**CITY OF TEMPE  
DEVELOPMENT REVIEW COMMISSION**

**Meeting Date: 9/26/2017  
Agenda Item: 4**

**ACTION:** Request for an Amended Planned Area Development and Development Plan Review consisting of a new 18 story, 225 feet high hotel and a Use Permit for entertainment for WESTIN TEMPE, located at 11 East 7<sup>th</sup> Street. The applicant is Sender and Associates.

**DEVELOPMENT PROJECT FILE**  
for  
**WESTIN TEMPE**  
(PL170238)

1 ENLARGED REFUSE PLAN  
1" = 10'

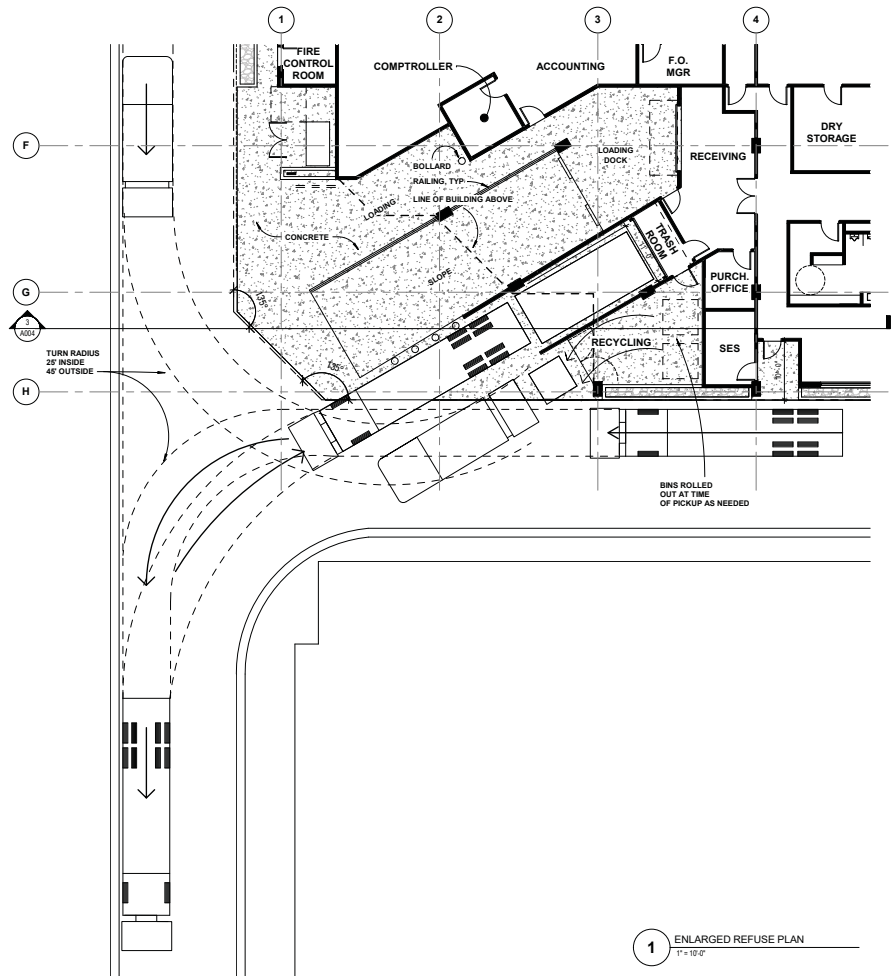
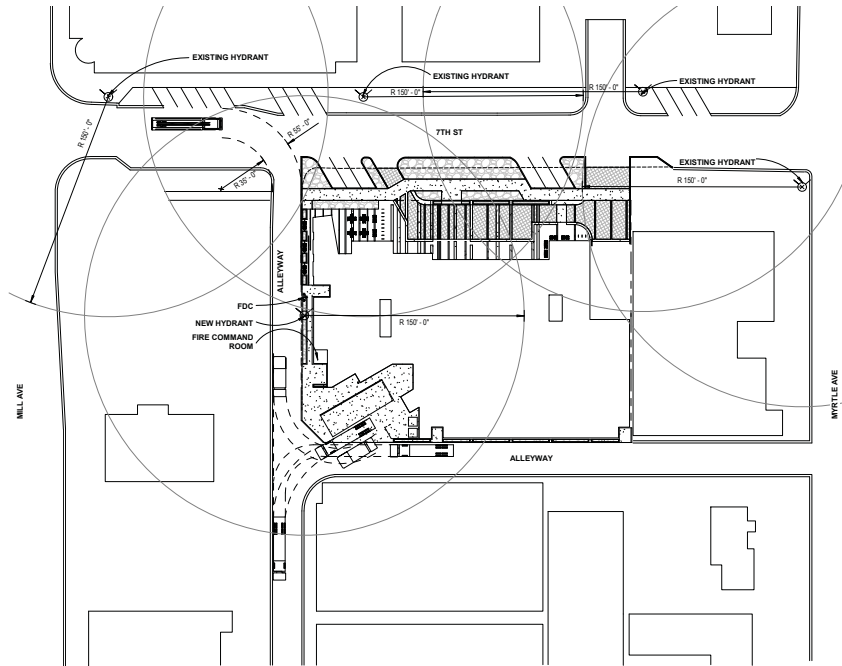
5. Provide service yard and mechanical yard walls that are at least 8'-0" tall as measured from adjacent grade and are at least the height of the equipment being enclosed, whichever is greater. Verify height of equipment and mounting base to ensure that wall height is adequate to fully screen the equipment.

6. Provide gates of steel vertical picket, steel mesh, steel panel or similar construction. Where a gate has a screen function and is completely opaque, provide vision portals for visual surveillance. Provide gates of height that match that of the adjacent enclosure walls. Review gate hardware with Building Safety and Fire staff and design gate to resolve lock and emergency ingress/egress features that may be required.

2 NORTH ELEVATION  
1" = 30'

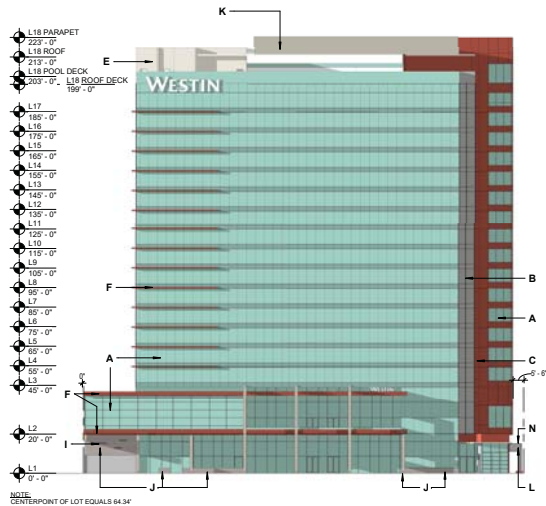
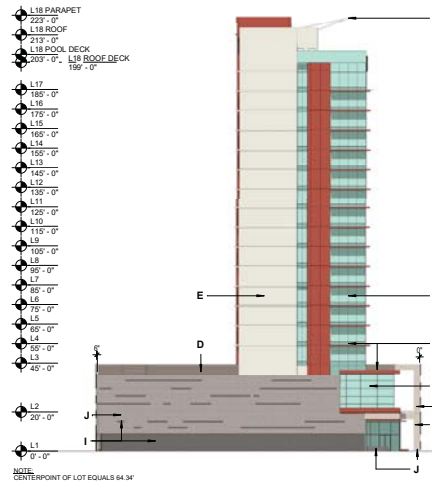
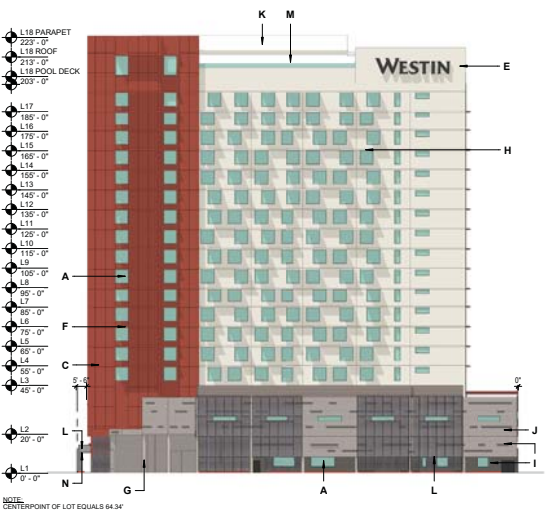
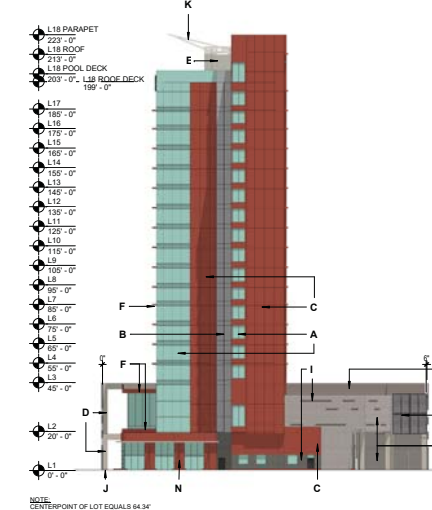
The south elevation has a dark fluted masonry veneer on the first floor, accented by a lighter ground faced masonry unit on the columns. Windows were added to the back of house functions to increase surveillance and security of this area from employee spaces. The windows are set back from the property line and planters line the south side alley with sculptural plants overlooked by the shaded windows. 1" thick fiberglass trellises extend from these planter boxes up to the upper floors breaking up the patterning of the masonry and slot windows on the second floor, while providing shade. Levels three through eighteen are predominantly stucco, with recessed and canopied windows at the west end. The primary body of the building has windows that are off-set on each floor, a random pattern created. This was intentional design, however unintentional it appears. Shade canopies vary from single to double wide, casting shadows on the wall for added dimension. The attention to detail on the south elevation presents a unique back of house façade and transforms the alley through architecture and landscape enhancement.

The east elevation uses the masonry base for the first two floors where a zero-lot line prevents window usage. Although spandrel glazing was added to the north east corner to wrap the glass element, discussions with the property owner to the east indicate that a zero lot line design would conceal the spandrel glazing proposed. Without having an application entitled for the lot to the east, staff has added a condition regarding the aesthetic design of this corner. It is anticipated that the adjacent property would also have a zero lot line configuration, but in the event that this does not occur, or is delayed, the spandrel glass would be installed per the rendering. The upper floors have stucco finish on the south side and the glazing from the north elevation wraps to the east elevation. The upper floors are set back 27' to allow window openings to a specified percentage per building code.

The west elevation recognizes the existing alley grid as more than a service corridor. The ground floor starts with storefront at the north end where the restaurant patio wraps the corner of the building. A sheltered sidewalk along the west side runs under an arcade of planted trellises separated from the alley by raised planter boxes. Between service doors, windows were added to enhance surveillance of the area. All deliveries and refuse collection is done at the southwest corner of the site, in an open and illuminated area for safety. The upper floors of the west side are a combination of glazing wrapped from the north elevation, and a band of red stucco that forms a tower along the south west corner of the building. The color was chosen to tie into the red brick along Mill Avenue, without replicating traditional clay brick. Staff had understood this material to be a metal panel or large tile product initially, however final design submittal indicated this element was an insulated

- b. Primary Building – Exterior Insulated Stucco System Painted Custom (cream color) not to exceed 75% LRV
  - c. Southwest tower element – In lieu of EIFS, provide alternative building materials such as large format porcelain, stone or concrete tile or metal panel system to match the rendering color and pattern.
